Author Response to Referee #1 (RC1) and Community Comment (CC1)

Manuscript EGUSPHERE-2026-1605

Assessing Buried Landslide Rupture Surfaces Using Genetic Algorithms and Dynamic Flow Modeling

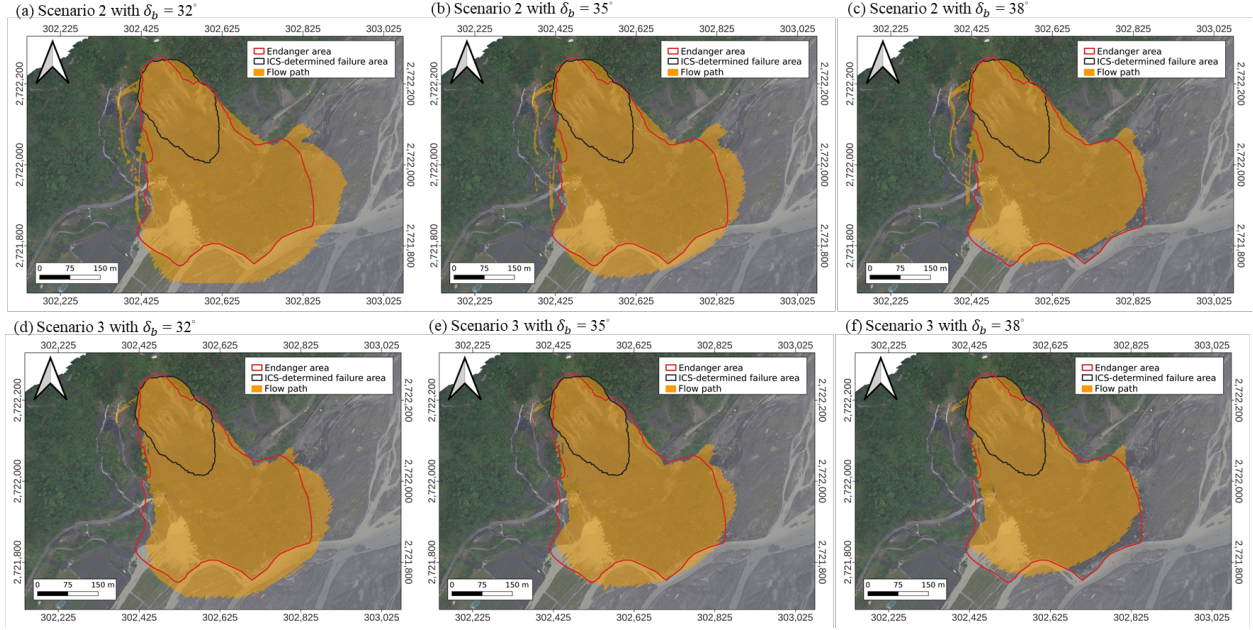
[...] if the angle of basal friction was varied by ± 3 degrees, would the numerical results be noticeably different in terms of run-out distances and deposition coverage accuracy? I think that a brief analysis on these sources of uncertainty could enhance the impact of the work.

Additional analysis of varying δ_b by $\pm 3^\circ$ (namely, 32° , 35° , 38°) are performed for candidate rupture surfaces of Scenarios 2 and 3 for the Provincial Highway No. 7 event (Table R1, Figure R1). With respect to 35° , these additional two metrics constrain δ_b from opposite sides. At 32° the deposition coverage has already declined to its poorest values (0.71 and 0.76), so lowering δ_b further is unwarranted. At 38° the coverage gain is marginal (below one percentage point) but the run-out is underestimated by 13%. The adopted $\delta_b = 35^\circ$ reproduces the measured run-out of 269 m for Scenario 3 to within 0.2%, and therefore provides the best balance among flow path, deposition depth, and run-out distance. These information will be added into the revised MS.
